MAINTENANCE INFORMATION

MI12-48

| SUBJECT : | 4-INCH OD TURBO OUTLET PIPE – CLEARANCE WITH CLOSE SUPPORT BRACKET | | |

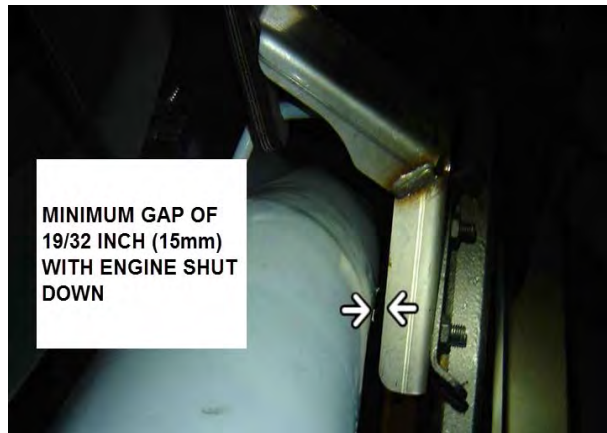
2) The picture below shows the area where interference between the 4-inch OD turbo outlet pipe and the close support bracket may be present.

3) With the engine shut down, the minimum gap should be about 19/32 inch (15 mm).

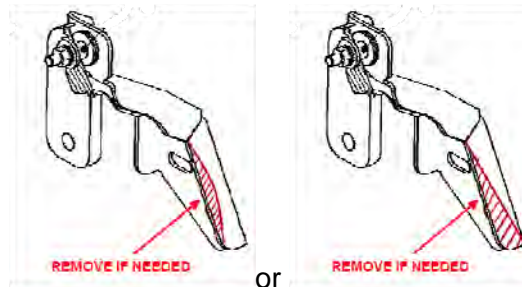
4) If evidence of rubbing is found, remove the support bracket and cut a part of the support bracket out as shown (as per image at left or at right as needed) and trim sharp edges.
